Access Compliance Report Public Rights-of-Way (Curb Ramps)

Intersection ID: 54210 Main Street: GANNON DR Cross Street: RACHEL FREEMAN WY Location: N **Severity Score:** 12.5 **ADA ID: 18A45EAFBE32** Ramp Type: BlendTrans1 Initial Pass/Fail: Fail **Overall Compliance: No**

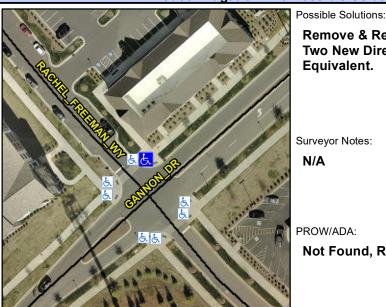
Street 1 Name Stop Condition-Street 1 Street 2 Name Stop Condition-Street 2 Remove & Replace Curb Ramp With Two New Directional Ramps or Equivalent.

Not Found, R304.5.3

Yes N/A Ramp Length (in) 96.0 BlendTrans Slope (%) 3.4 No Yes Ramp Width (in) 60.0 BlendTrans XSlope (%) 5.2 N/A N/A Flare Type LT N/A Flare Type RT N/A N/A Flare Slope LT (%) N/A N/A Flare Slope RT (%) N/A N/A Flare Traversable LT? N/A N/A Flare Traversable RT? N/A N/A Landing Length (in) N/A N/A **DWS Provided?** N/A N/A Landing Width (in) N/A N/A **DWS Contrast?** N/A N/A N/A N/A Landing Slope (%) DWS Length (in) N/A N/A Landing X Slope (%) N/A N/A DWS Full Width? N/A N/A Landing Curb? (Y/N) N/A N/A DWS Offset (in) N/A N/A N/A Shared Landing? N/A **Gutter Ponding?** N/A N/A Gutter Slope (%) N/A N/A Gutter Lip Ht (in) N/A N/A Gutter X Slope (%) N/A N/A Painted X Walk1? No N/A Painted X Walk2? N/A X Walk 1 Direction To SE X Walk 2 Direction N/A N/A X Walk 1 Width (in) X Walk 2 Width (in) N/A X Walk 1 Slope (%) 4.0 X Walk 2 Slope (%) N/A X Walk 1 X Slope (%) 2.5 X Walk 2 X Slope (%) N/A N/A N/A Ramp inside XWalk2? N/A Ramp inside XWalk1? N/A Road Slope (%) 2.5 Clear Space? N/A N/A Road X Slope (%) Clear Space to XWalk (in) N/A 4.0 N/A N/A N/A Any Obstructions? Storm Grate/Utility Hazard? N/A **Obstruction Type** Storm Grate/Utility Type N/A N/A Yes Surface Condition? (G/P) Good No Curb Slope (%) 8.6
